UNITED STATES PATENT AND TRADEMARK OFFICE

APPLICATION NO.	FILING DATE	FIRST NAMED INVENTOR	ATTORNEY DOCKET NO.	CONFIRMATION NO.
09/980,254	02/08/2002	Jacques Sebban	05725.1001	1052

Office Action Summary

DETAILED ACTION

Fig "A" (cf. Fig. 6)

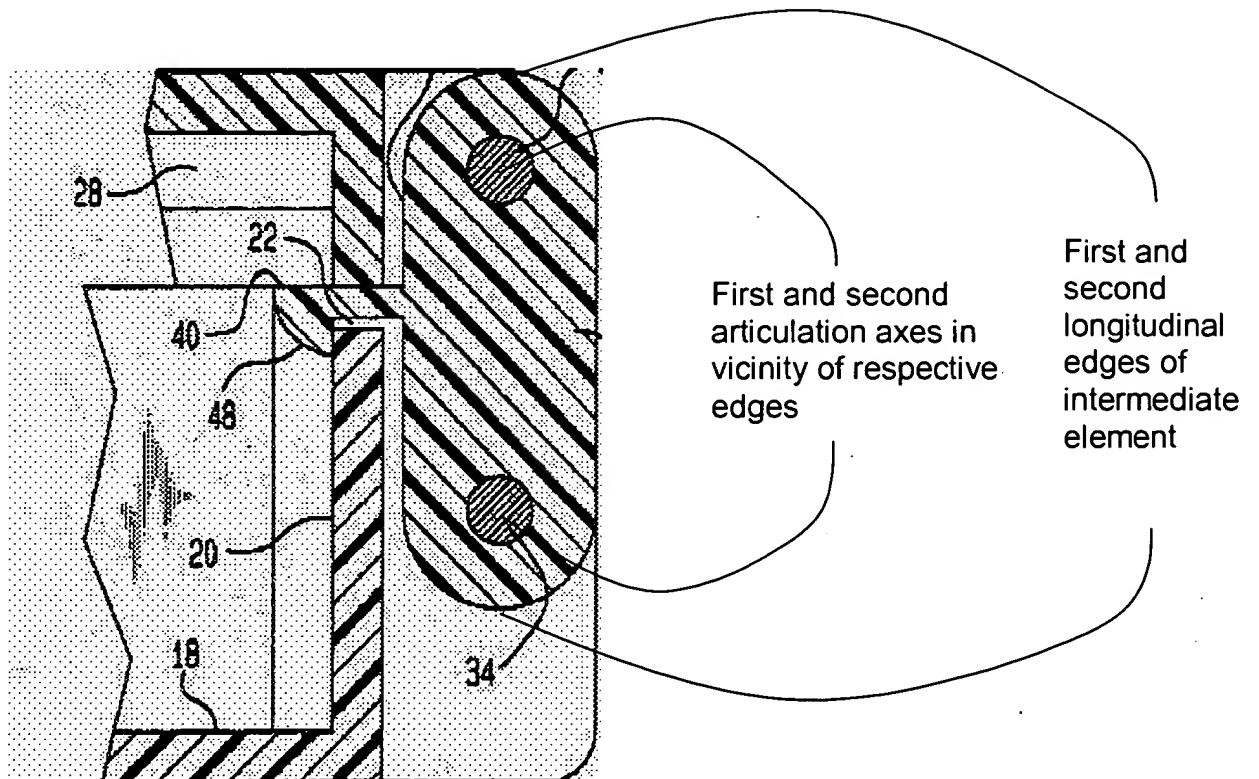
Lunderman et al. disclose a compact 10 comprising a base 12, an intermediate element 30, and a lid 14 (see Figs. 1-6). The base defines a housing 18 for the cosmetic product (see col. 2, lines 59-61). The base includes a first catch member 22 defined by an opening extending in a plane in a lateral wall 20. The intermediate element includes a second catch member 40 that flexes elastically in a direction perpendicular to a longitudinal axis of the intermediate element and snaps together with the first catch member to irreversibly lock the intermediate element to the base (see col. 2, lines 17-20 and col. 3, lines 38-47). The catch member includes a hook portion 48. The lid is articulated on the base via the intermediate element such that it can pivot through 360 degrees relative to the base (see col. 2, lines 12-16). When the catch members are engaged and the intermediate element is irreversibly locked to the base, the intermediate element is arranged substantially entirely on one side of the plane (see Fig. 6, showing the intermediate element substantially entirely to the right of the plane of the opening, as opposed to the base, which is to the left of the plane). The intermediate element includes first and second longitudinal edges and corresponding first and second articulation axes in the vicinity of the edges (see Fig. "A" below). The compact can be formed as an integral piece by molding and either or both of the hinges can be formed as pin or living hinges (see col. 3, lines 7-16). The lateral wall is delimited by a first edge adjacent the lid when the lid is closed relative to the base and a second edge opposite the first edge, and the first catch member 22 is at a distance from the first edge (see Figs. "B" and "C" below).
